IN REPLY REFER TO:  
3482, U-020668, U-38727  
(UT-923)

Re: Minor Modification, Resource Recovery and Protection Plan (R2P2), Pillar Extraction Mining Under Escarpments, Wild Horse Ridge Area, Bear Canyon # 3 Mine

**Bear Canyon #3 Mine  
Blind Canyon Seam**

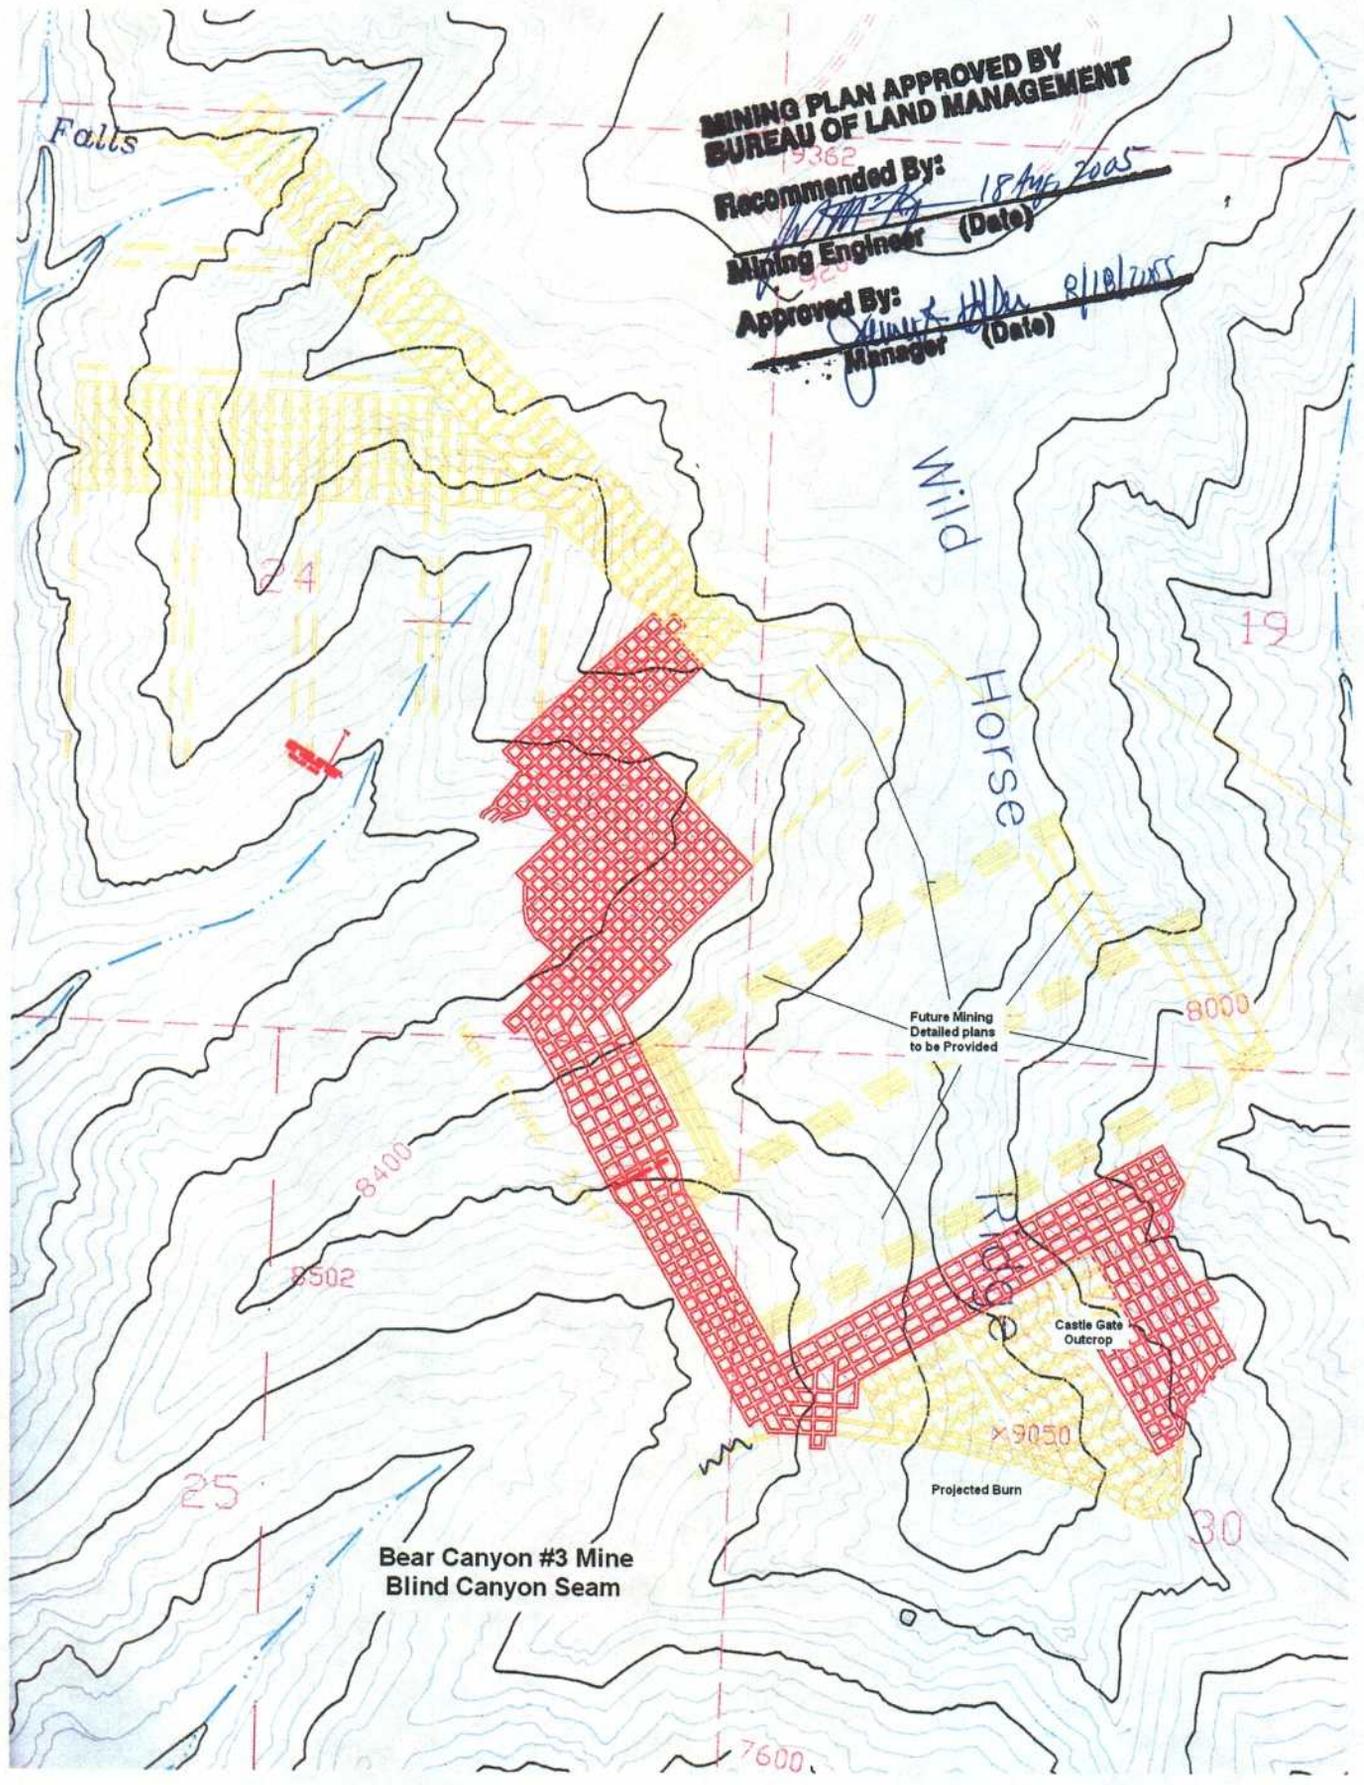
First, the outcrop of the Castle Gate sandstone above the proposed pillar extraction panel is facing northeast and is a vegetation covered steep slope, not a rock outcrop cliff. Arial photographs show under stereoscopic examination, no cliff faces of any significance but for one ledge estimated at 15 feet high. We do not believe this qualifies as an escarpment.

Second, the amount of subsidence should be very minimal. The panel width is only 700 feet and critical width would not occur. Hence, it is estimated that less than 2 feet of actual (partial) subsidence should occur above the room and pillar panel. Though it is impossible to predict exact amounts of rock failure due to subsidence, the small ledge should not be affected.

Third, if any rock failures occur, they would be limited to the exposed rock which is the identified rock ledge. Any failure would be minor. The Manti LaSal National Forest has stated that any surface resources would not be impacted by minor rock failures due to subsidence (e-mail response, 7/14/05, Dale Harber, Manti-LaSal National Forest).

The BLM requests C. W. provide, within 60 calendar days, a mine plan showing the sequence and timing of mining for the areas shown on the approved map and a comparison of recoverable reserves before and after this mine plan modification.

C. W.'s proposed changes to the R2P2 complies with the Mineral Leasing Act of 1920, as amended, the regulations at 43 CFR 3480, the lease terms and conditions, and will achieve maximum economic recovery of the Federal coal. C. W. is authorized to extend development south off the east submains in the # 3 Mine to the limits of the outcrop burn on south Wild Horse Ridge and retreat mine with full pillar extraction (as shown on the attached approved map). This approval is conditioned on continued monitoring of the Castle Gate sandstone outcrop above the mining area. Should significant rock failure occur, BLM is to be notified so that a determination of remediation or mitigation, if necessary, can be made. A copy of the approved mine map is enclosed.
